From: Laura Gibbons <laura.gibbons@adur-worthing.gov.uk> on behalf of Laura Gibbons
Sent: 14 June 2022 09:50
To: Peter Barnett
Subject: Fwd: AWDM/0343/22 - 5 Commerce Way, Lancing Business Park
Attachments: 21-008D_300-P8 DRAINAGE LAYOUT AND EXTERNAL LEVELS.PDF; 21-008-FULL NETWORK REV P3.pdf

Project Title: **5 COMMERCE WAY, LANCING.**

Drawing Title: **DRAINAGE LAYOUT AND EXTERNAL LEVELS**

Drawing Number: **21-008D / 300** Rev. **P8**

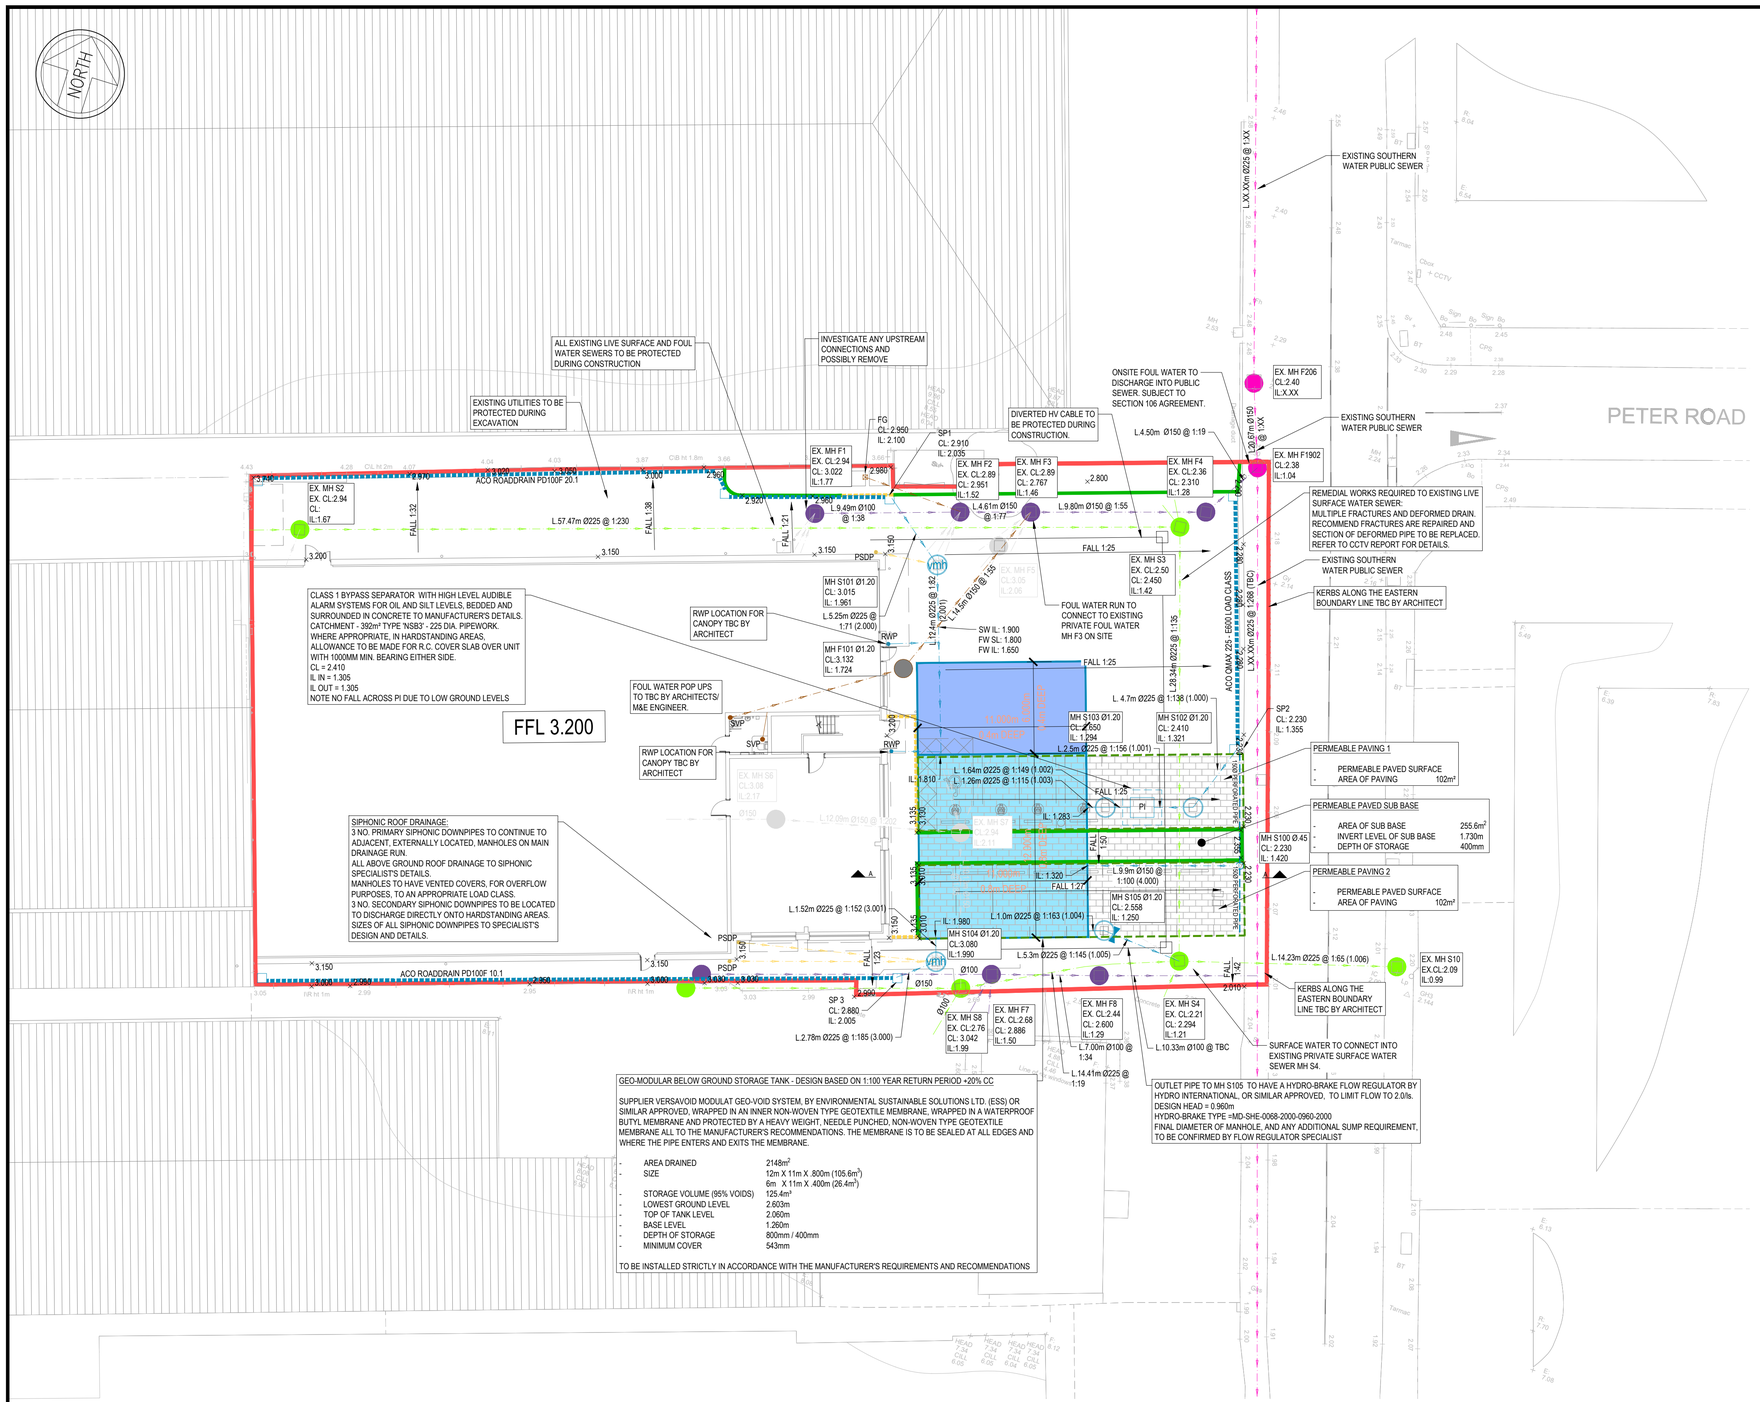
The 1 in 100 year plus 40% cc event calculation results previously supplied (with a different hydrobrake and higher discharge rate) show flooding of circa 24m3. It appears that the site is proposed to fall towards the road. Therefore, it is not clear how proposals will not result in water discharging from the site in the 1 in 100 year plus 40% cc event. And therefore our doubts regarding whether a policy compliant design is achievable on site remain.

We would recommend the high level strategy is updated so that the design event includes a 40% allowance for climate change and demonstrates this can be safely contained on site. This should be provided prior to determination.

1. *Provide calculations to evidence if infiltration is viable on site utilising a blanket infiltration solution.* Unfortunately, due to the low external levels to the unit and the high groundwater level it is not possible to rely upon infiltration devices as the primary source of surface water discharge.

4. *Provide a revised attenuation design with discharge limited to 2l/s.* See attached our updated drainage layout and microdrainage calculations that allow for 2 l/sec discharge rate. *Calculation results show a discharge rate of 2.2l/s for the 100 year plus 20% event. Please revise specified flow control to ensure 2l/s is not exceeded.*

a) Consistency of permeable paving area modelled. Layouts show two areas of 102m2, calculations include circa 234m2, i.e. calculations are currently over providing. Please correct this to provide consistency.

b) Please apply a cap volume depth to permeable paving within calculations to reflect the 300mm depth of sub-base.

The calculations have been re-run and the drainage layout has been updated to include an enlarged attenuation tank.

The enlarged portion of the tank has been located below the service yard and to maintain a suitable cover, this portion of the tank will be 400mm deep and connected at the invert level of the original tank.

Rev.	Tech	Date	Description
P8	NDH	26.05.22	UPDATED IN LINE WITH COMMENTS RECEIVED FROM LLFA
P7	NDH	05.05.22	PERMEABLE PAVING AMENDED AND REMEDIATION NOTES ADDED. HYDRBRAKE MODEL UPDATED.
P6	JJ	04.04.22	EXISTING MANHOLE COVER LEVELS UPDATED AND KERBS ADDED. DISCHARGE RATE REDUCED AS PER COMMENTS FROM LLFA AND TANK SIZE INCREASED.
P5	JJ	21.02.22	PSDP LOCATION UPDATED.
P4	JJ	18.02.22	MH F100 REMOVED AS PER CLIENT'S REQUEST.
P3	JJ	17.02.22	TANK MOVED TO AVOID CLASH WITH LV CABLE DIVERSION
P2	JJ	16.02.22	PRELIMINARY ISSUE
P1	JJ	25.01.22	WORK IN PROGRESS ISSUE
